APPLICANT : MAURICE PALESCHUCK  
PATENT NO. : 6,994,022  
SERIAL NO. : 10/676,681  
ISSUE DATE : FEBRUARY 7, 2006  
TITLE : AIRCRAFT TRASH MANAGEMENT SYSTEM

REQUEST FOR CERTIFICATE OF CORRECTION

## UNITED STATES PATENT AND TRADEMARK OFFICE CERTIFICATE OF CORRECTION

FIG. 21

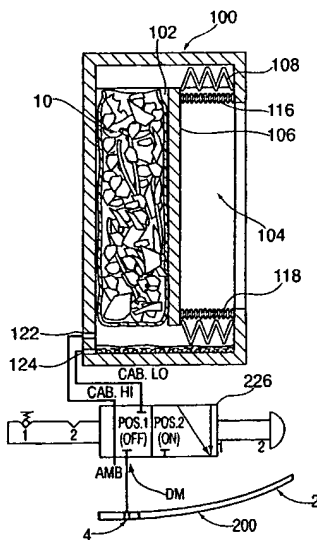
In addition, Applicant seeks to correct minor errors in Figure 21. These amendments to Figure 21 were mailed on July 18, 2007 in a related continuation application Serial No. 11/324,661 (Exh. A) and were accepted in the Office Action dated October 9, 2007 (Office Action Summary enclosed as Exh. B). As seen in Figure 21 of the Certificate of Correction, it has been corrected to properly label Position 2 (ON), the compact and drain position of valve 226, as described on the last paragraph on page 17 of the specification. In addition, the vertical connector line on the right hand side of valve 226 has been adjusted so that it connects to the diagonal arrow connector and an arrow head has been added to the vertical line of the right hand side of valve 226, so that the same functions as correctly set forth in the specification at pages 17-20.

These amendments were made so that the schematic diagram of the four port, two position switch as described on page 17 will properly conform to the specification. Specifically the amendments were necessary to show that when the switch is in Position 2, the ON position, that both Cab hi and Cab low will be connected to dm and amb will be blocked (see specification p.16). The addition of the arrow head was necessary to show the connections when the switch is in Position 2 (ON) (see specification p.16 ).

In the drawings, Sheet 13, Figure 21 should appear as follows:

FIG. 20

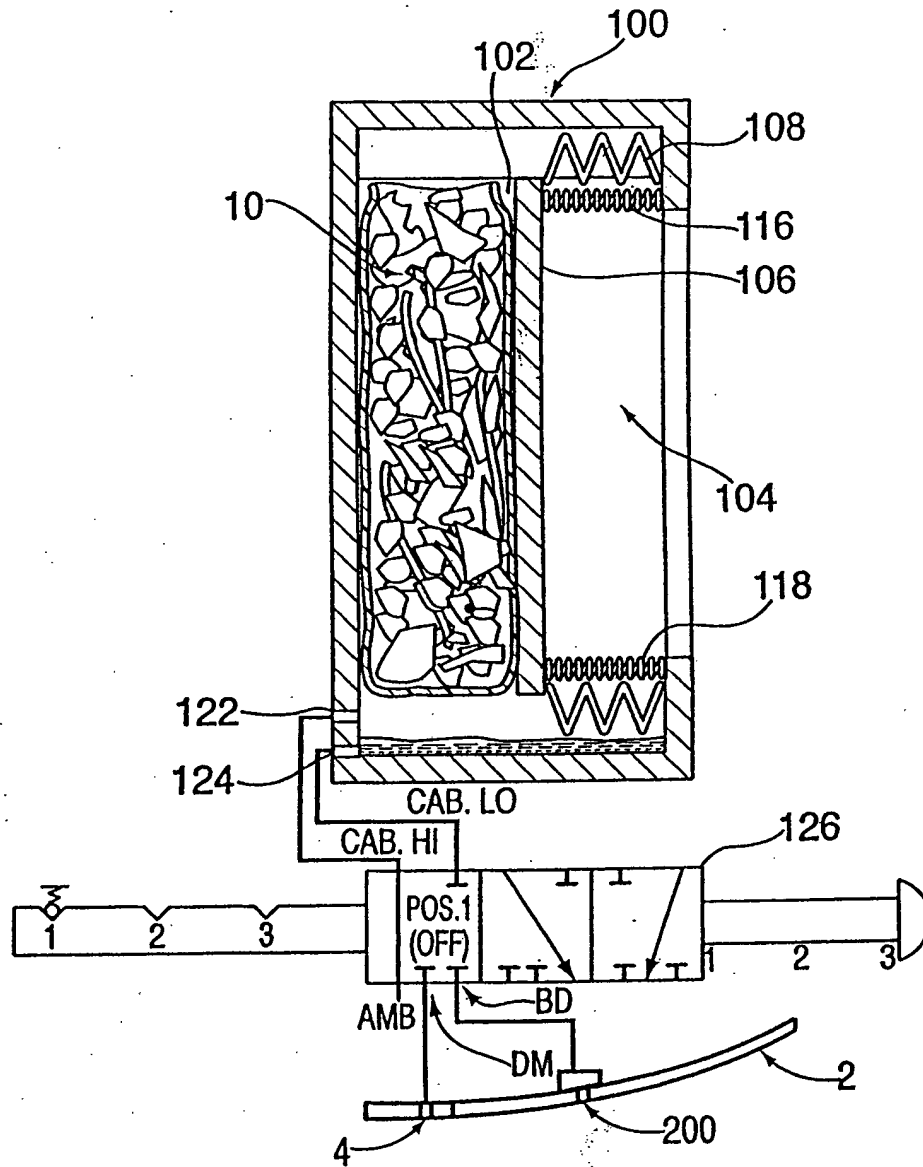
- - Referring now to Fig. 20, the compactor 100 of the invention is illustrated containing a trash filled bag 10 in the compartment 102 ~~104~~ and a schematic illustration of valve assembly 126 coupled to the ports 122, 124, the modified bilge valve 200 and the grey water drain mast 4. - -

FIG. 21

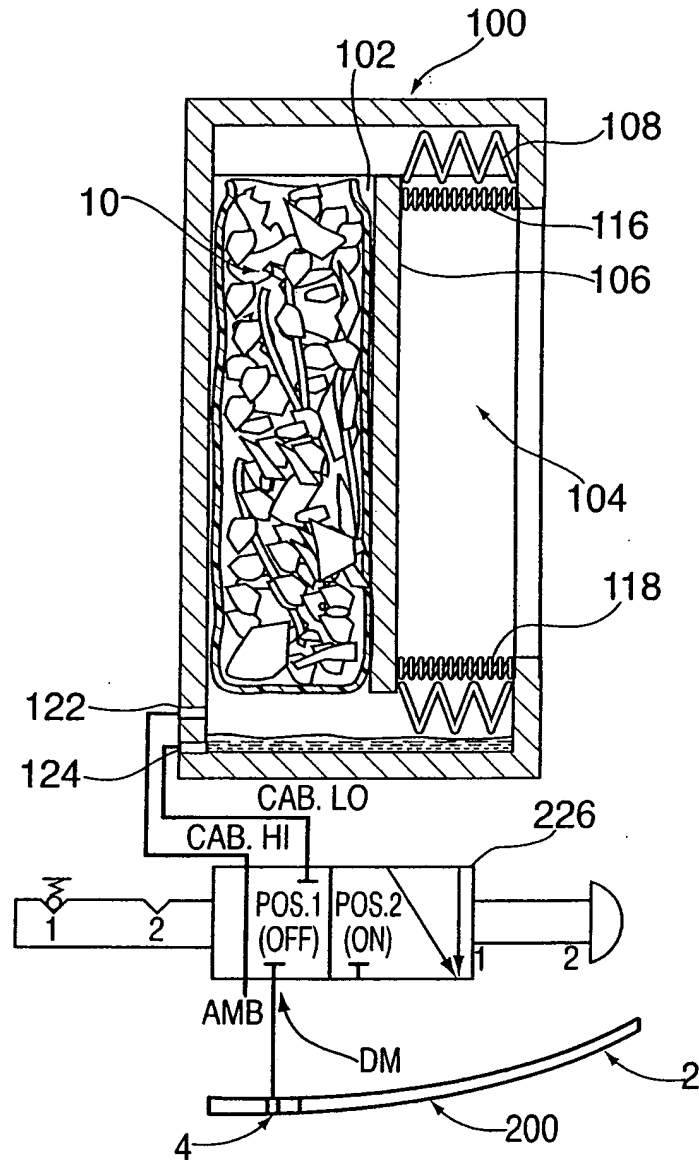
In addition, Applicant seeks to correct the Specification, and amend Figs. 18-21 as was done in the parent case by way of Amendment and to also correct additional minor errors in Figure 21. As seen on the Replacement Sheet for Figure 21 enclosed herewith, Fig. 21 has been corrected to properly label Position 2 (ON), the compact and drain position of valve 226, as described on the last paragraph on page 17 of the specification. In addition, two minor errors in Fig. 21 have been amended. In Fig. 21, the vertical connector line on the right hand side of valve 226 has been adjusted so that it connects to the diagonal arrow connector and an arrow head has been added to the vertical line of the right hand side of valve 226, so that the same functions as correctly set forth in the specification at pages 17-20.

These amendments were made so that the schematic diagram of the four port, two position switch as described on page 17 will properly conform to the specification. Specifically, the amendments were necessary to show that when the switch is in Position 2, the ON position, that both Cab hi and Cab lo will be connected to dm and amb will be blocked (see specification p.16). The addition of the arrow head was necessary to show the connections when the switch is in Position 2 (ON) (see specification p.16 ). It is not believed that these corrections add any new matter to the patent since they serve to simply illustrate the position of the valve as specifically described in the specification as noted above.
